NL-26-0269

Edwin I. Hatch Nuclear Plant – Units 1 and 2
Response to Request for Additional Information Regarding
Request for Alternative HNP-ISI-ALT-06-01
Implementation of BWRVIP Documents in Lieu of Certain B-N-1 and B-N-2 Examinations

**Response to Request for Additional Information Regarding
Request for Alternative HNP-ISI-ALT-06-01
Implementation of BWRVIP Documents in Lieu of Certain B-N-1 and B-N-2 Examinations**

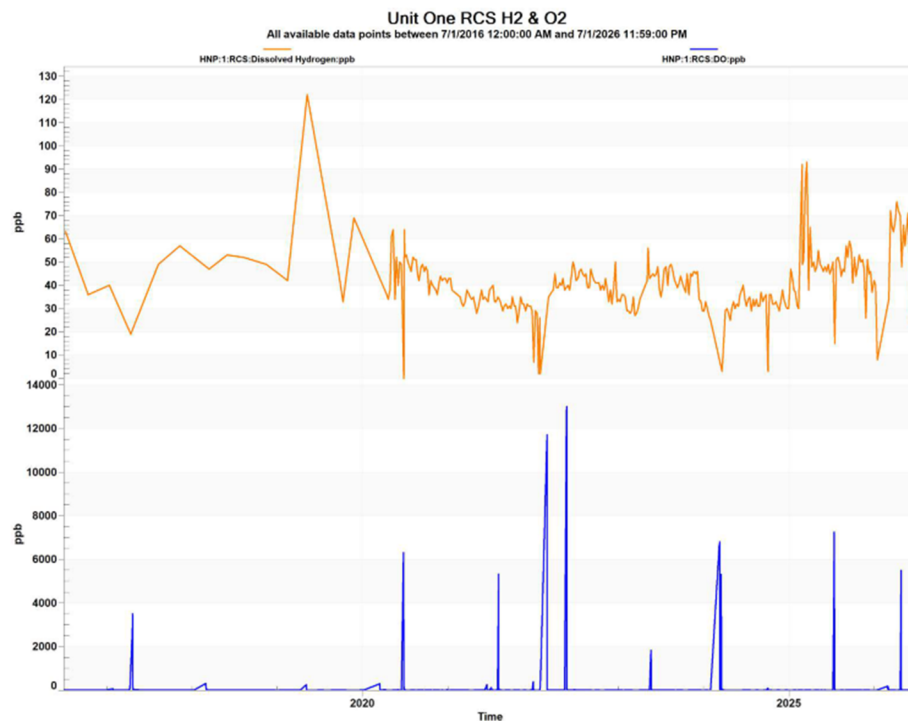
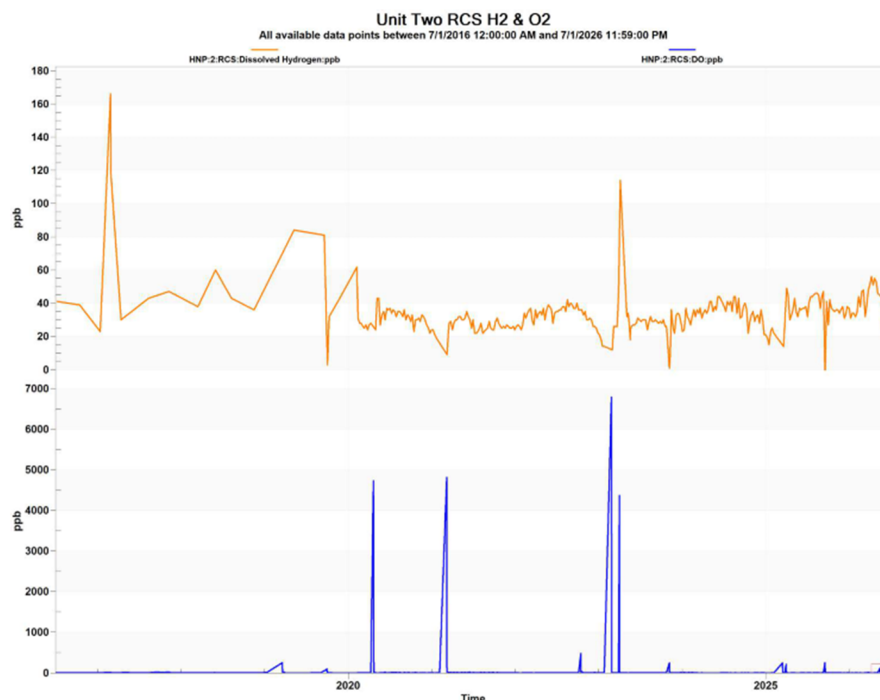
1. *Please discuss if the licensee will (a) apply the examination frequency based on NWC or HWC for the jet pump riser brace welds at HNP-1 and HNP-2, and (b) apply the examination frequency based on NWC or HWC/NMCA/OLNC for the core shroud support weld H9 at HNP-1?*
2. *Please discuss if the licensee plans to apply the examination frequencies for HWC or HWC/NMCA/OLNC and provide the criteria for effective HWC or HWC/NMCA/OLNC that would allow the modified examination frequencies and sample sizes to be applied.*

]] The tables below show HNP-1 and HNP-2 HWC availability over the past ~10 years and demonstrate that availability has been maintained greater than [[

- HNP-1 Cycle 29 HWC availability: 98.88%
- HNP-1 Cycle 30 HWC availability: 98.29%
- HNP-1 Cycle 31 HWC availability: 99.53%
- HNP-1 Cycle 32 HWC availability: 99.17%
- HNP-1 Cycle 33 through May 2026 HWC availability: 93.10%
- HNP-2 Cycle 26 HWC availability: 98.81%
- HNP-2 Cycle 27 HWC availability: 99.50%
- HNP-2 Cycle 28 HWC availability: 99.52%

- HNP-2 Cycle 29 through May 2026 HWC availability: 98.34%
